CONTRACT ADDENDUM NO. 3

April 6, 2026

NOTICE TO ALL BIDDERS FOR THE: **Topeka & Shawnee County Public Library** Staff Spaces Renovations HTK Project No.: 2001.01-021

SHEET NUMBER:
A101

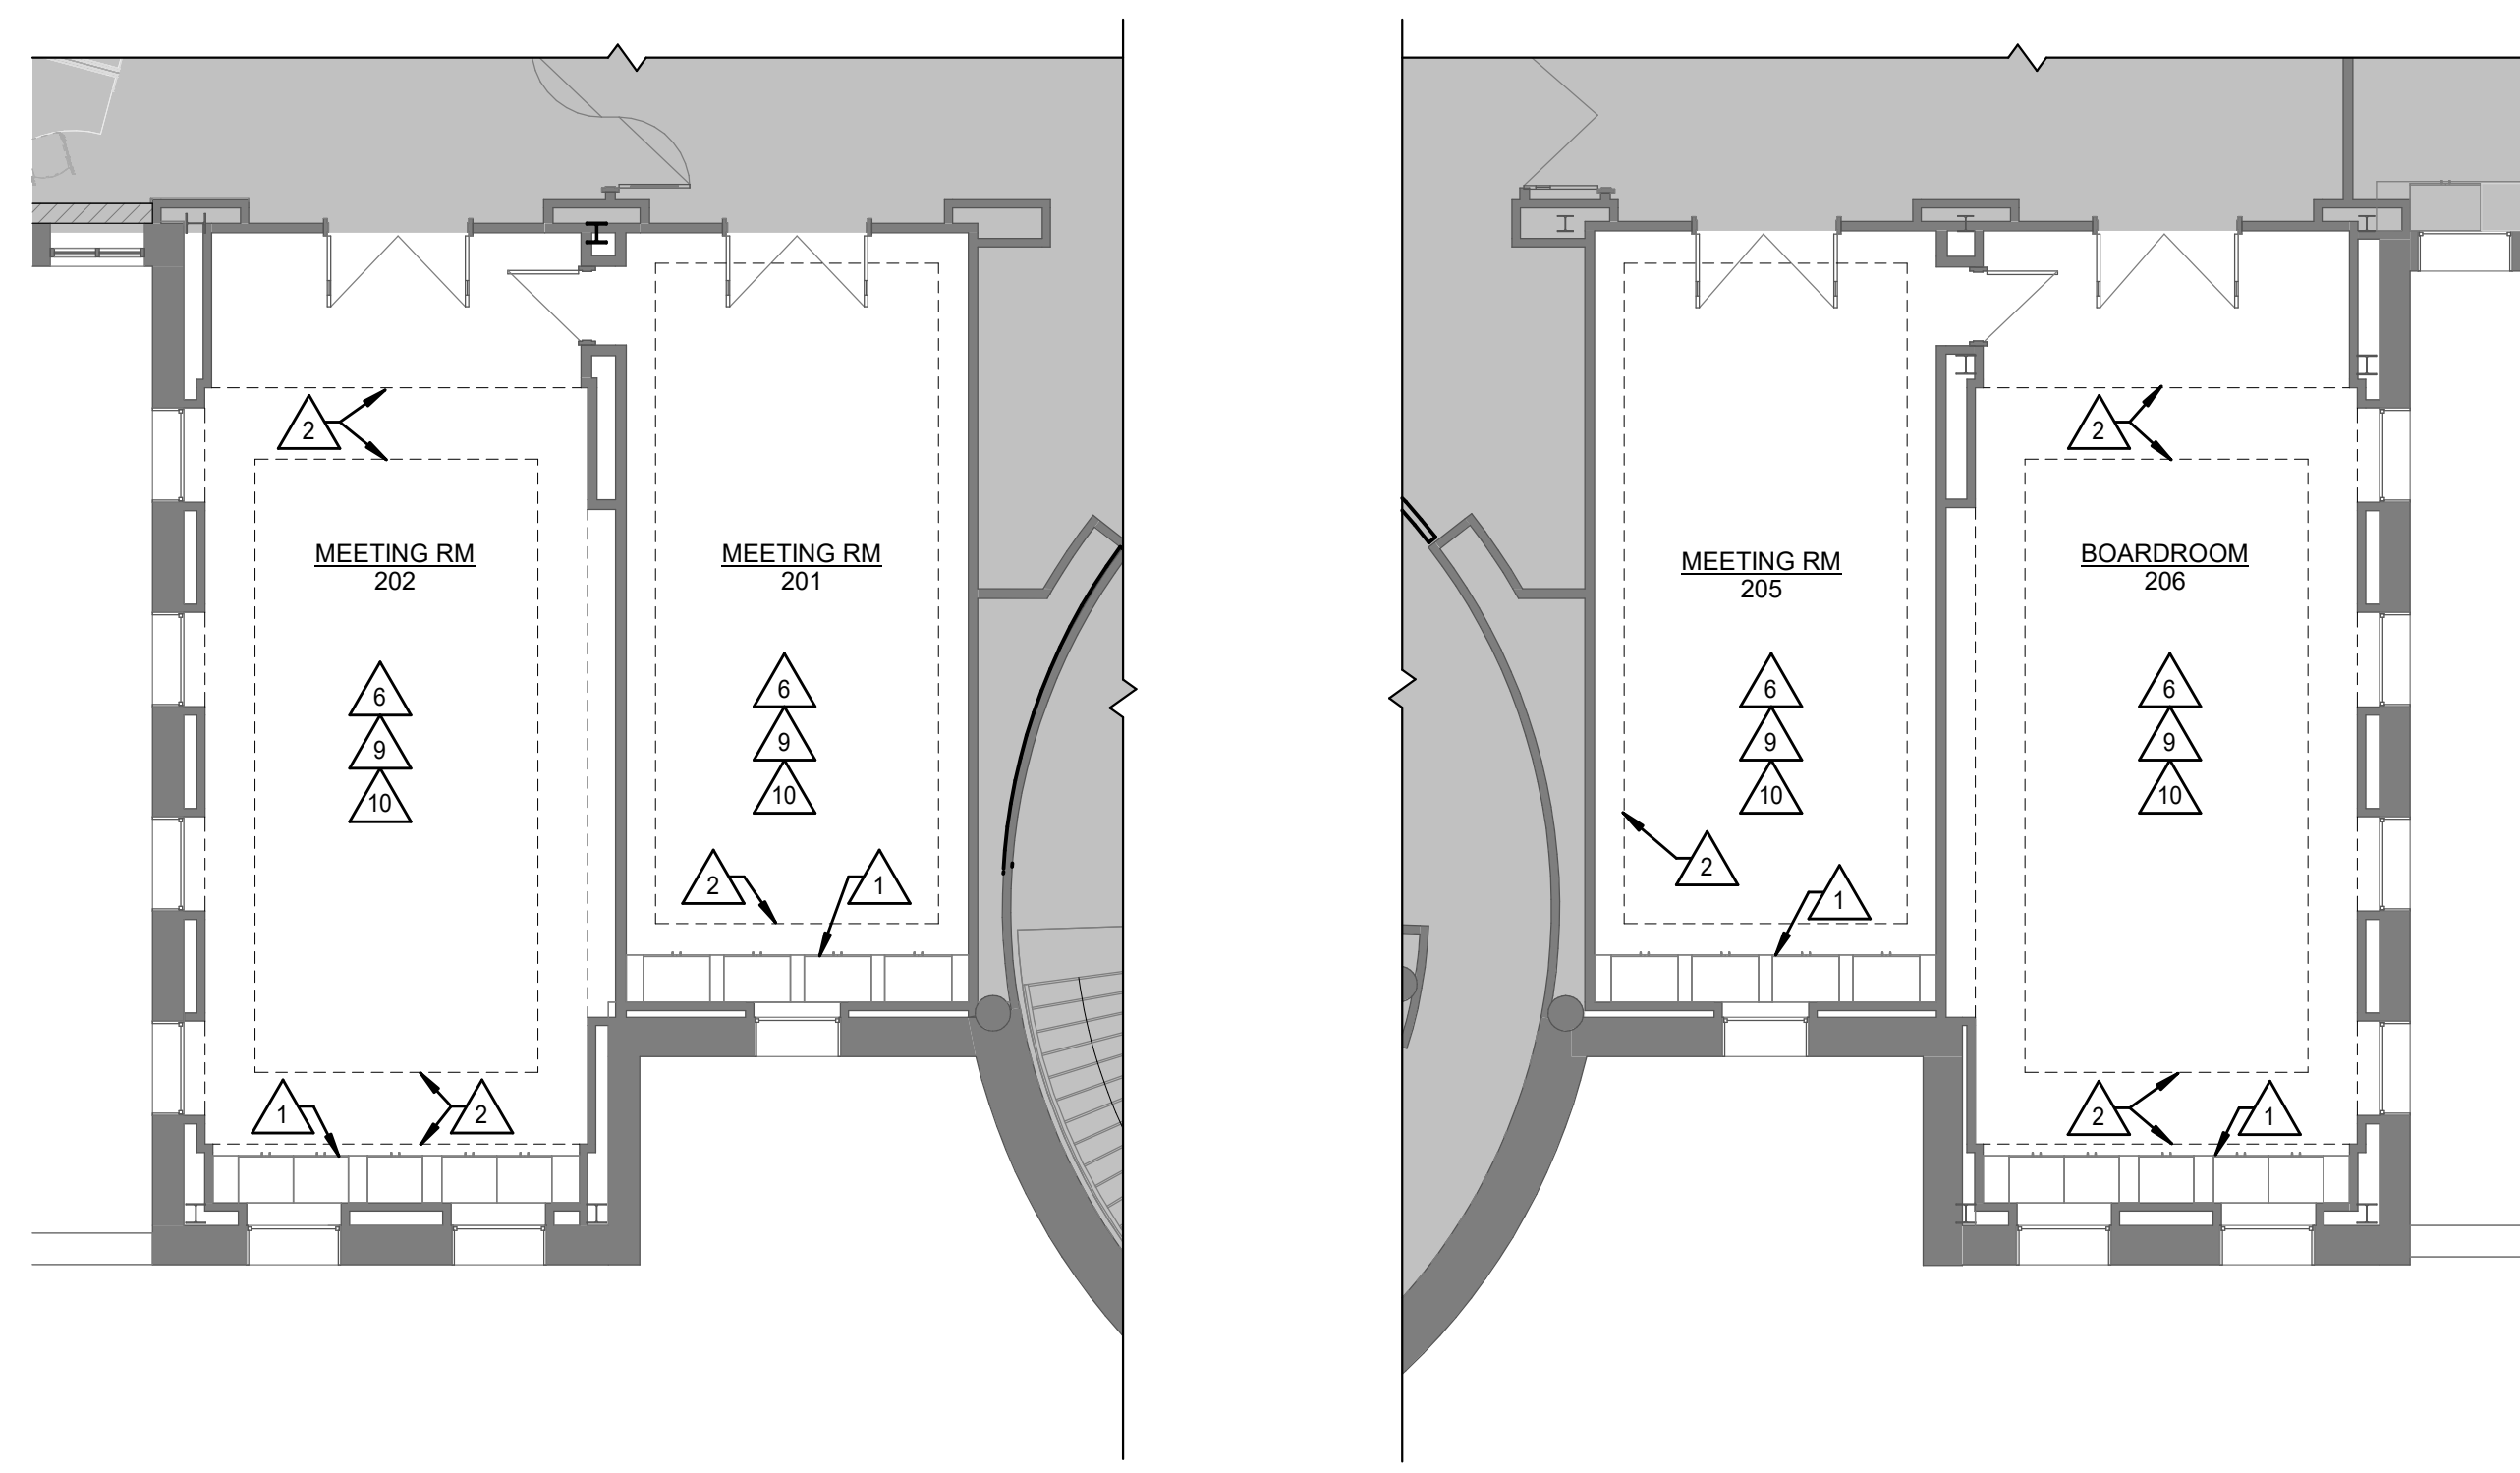
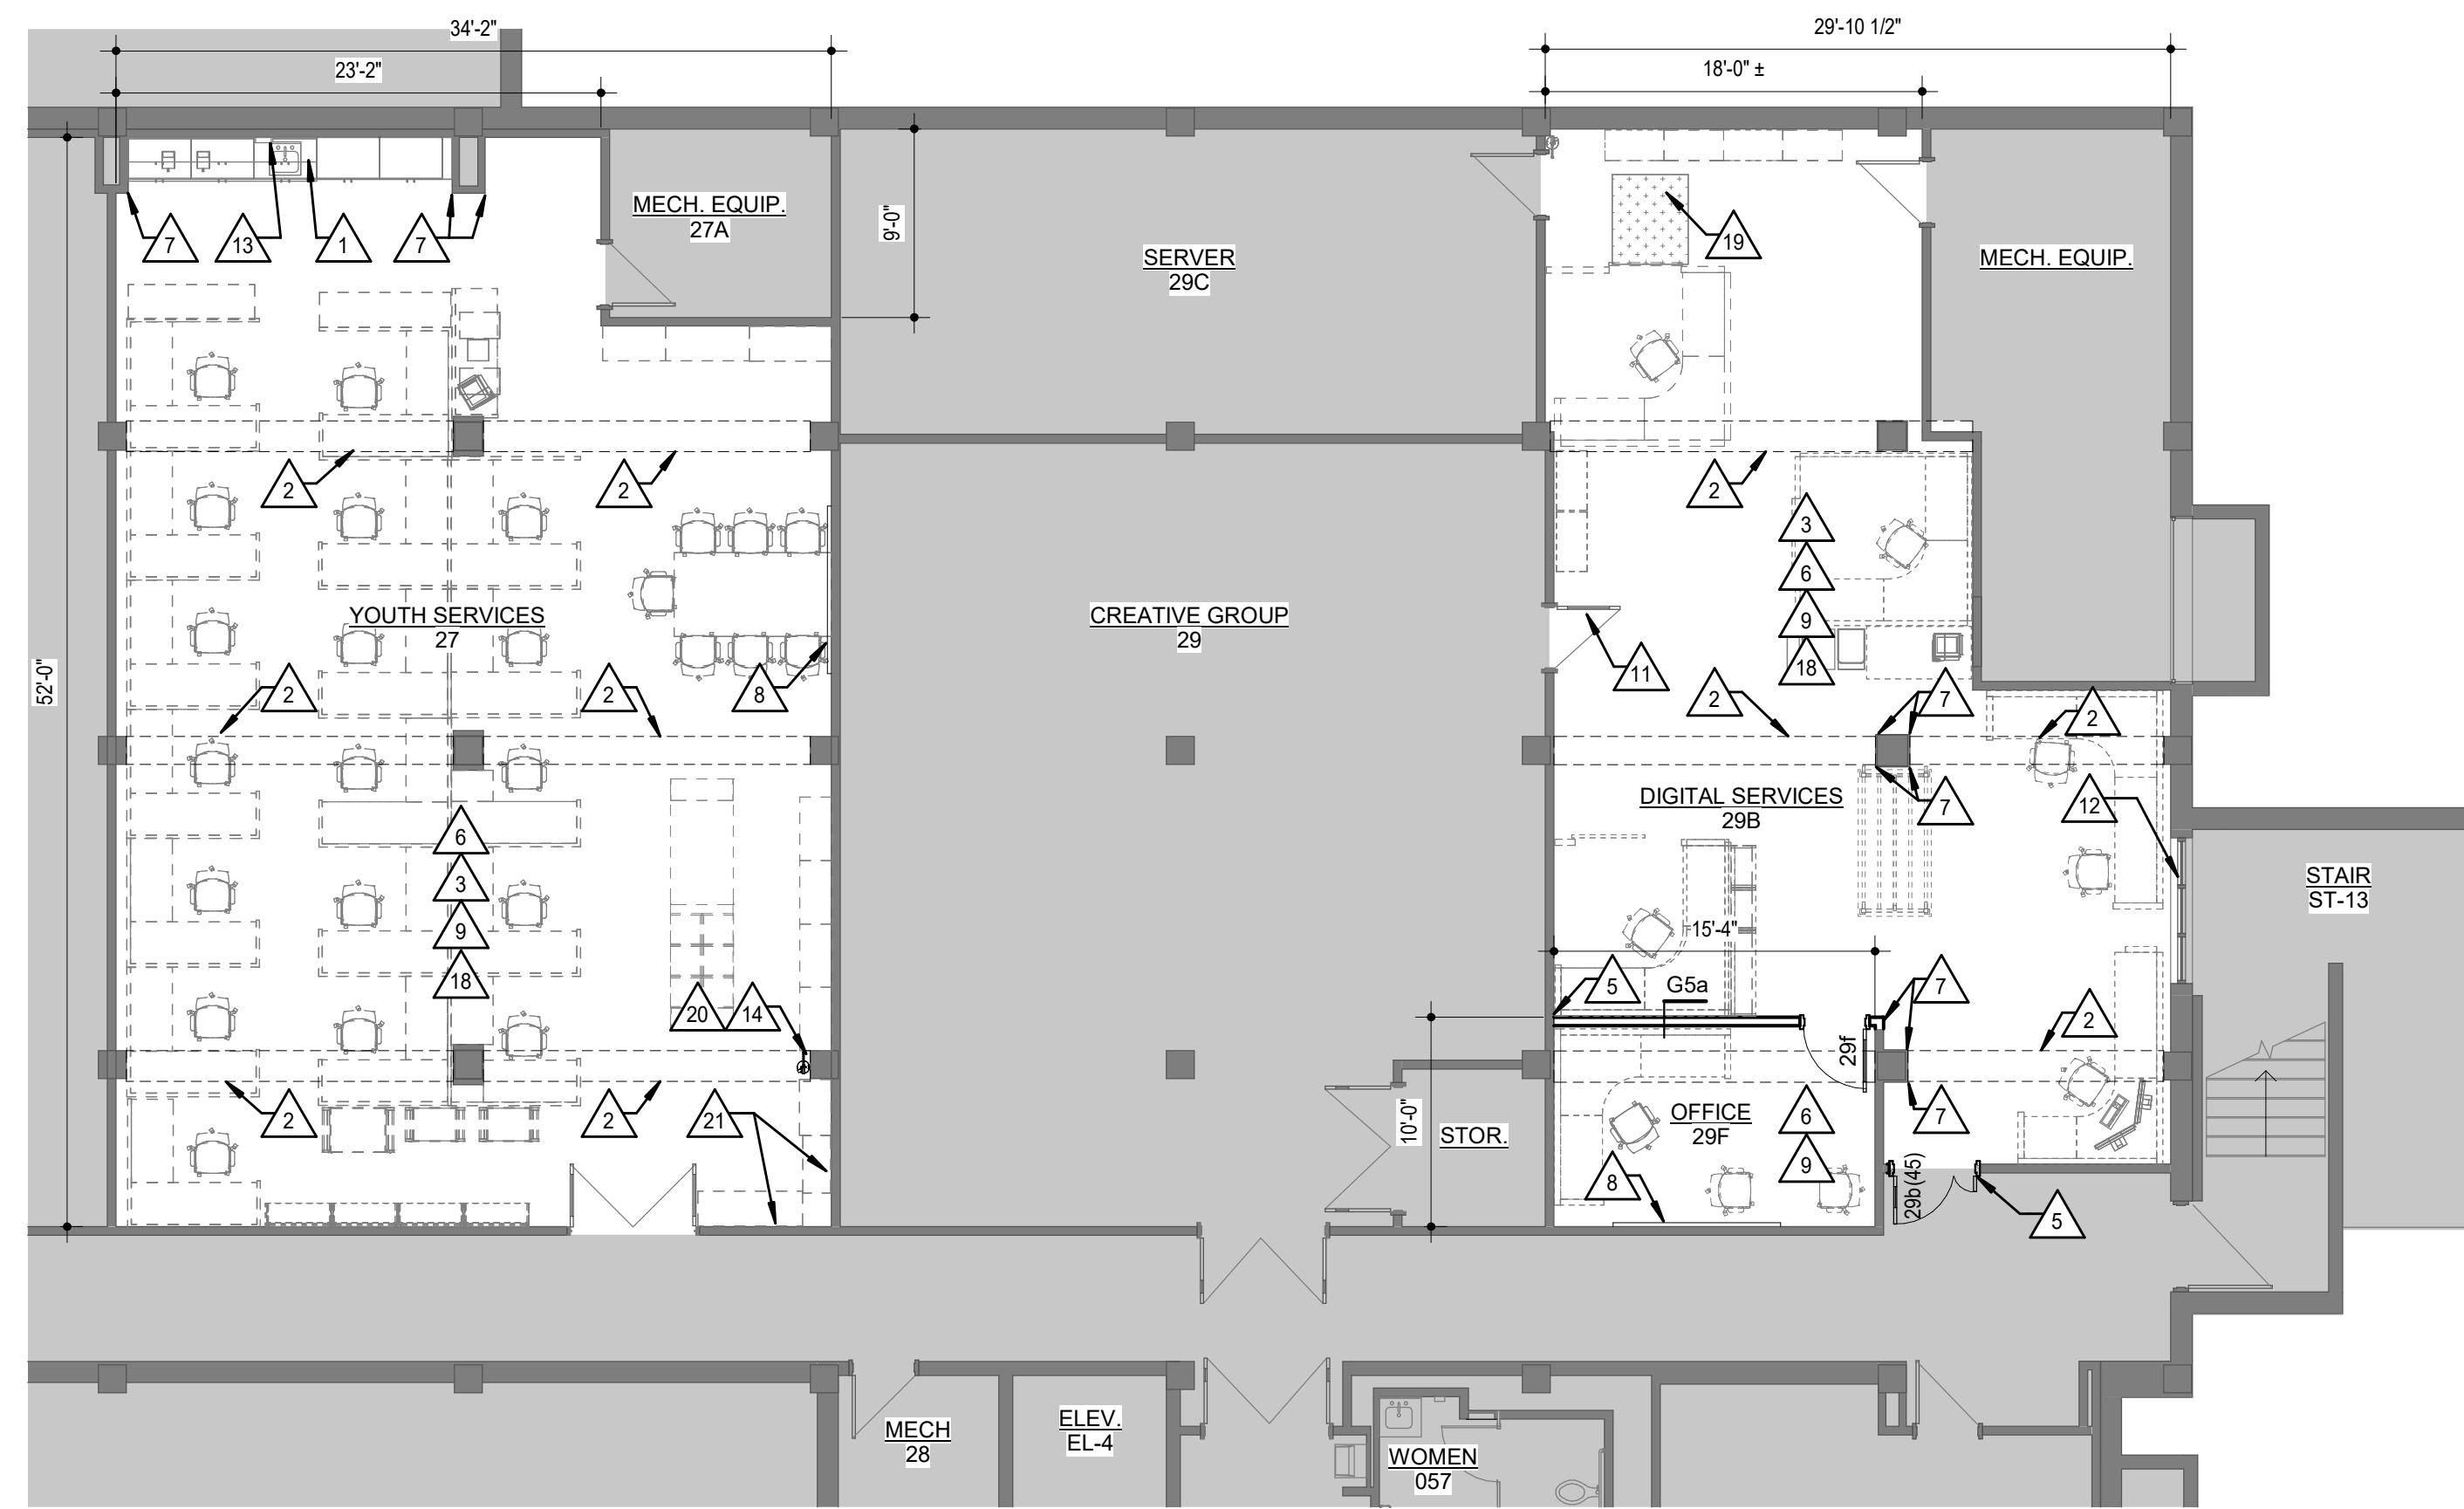
1. Revise Plan Note 15 to include Basis of Design roller shade information. Reference attached revised A101 Drawing Sheet.

- △ RELOCATE EXISTING FIRE EXTINGUISHER HERE
 - △ PROVIDE NEW ROLLER SHADE. BASIS OF DESIGN TO BE SWF CONTRACT - R-16 MANUAL ROLLER SHADE W/OUT FASCIA. BASIS OF DESIGN SHADE CLOTH TO BE SWF CONTRACT - CROSSHATCH R SERIES, R300
